**STAFF REPORT: JULY 12, 2023 MEETING**

**APPLICATION NUMBER: 23-8438**

**ADDRESS: 4217 LINCOLN**

**SCOPE: ERECT DORMER**

Above: Applicant rendering, south elevation.

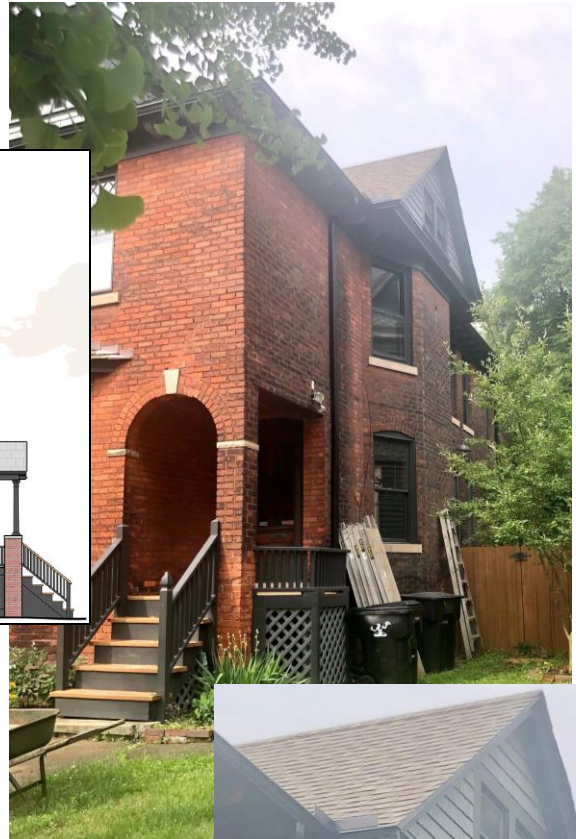
- The proposed dormer is similar in styling to the existing dormer, and the roof pitch matches that of the main structure. The eave line will remain intact, and the dormer’s ridge is slightly below the main roof’s ridge.
- The roof access window is further back and will not be visible.
- Comparing the elevation drawing and below photo, the rendering gives the impression of a much taller (higher pitch) roof than what is seen from the ground.

- The flatness and full view of the east elevation rendering makes the new dormer to be very visible and large. The house is not a symmetrical design, so the additional dormer adds balance to the roof massing, but in an uneven weight, which mimics the designs and proportionality of the front entrances.
- The position of the house, close to the street, offers limited visibility of the side elevation roofs. Similar to the comparison of the south elevation on the previous page, it is staff's opinion the new dormer will not be as impactful to the front elevation as depicted in the elevation drawing.
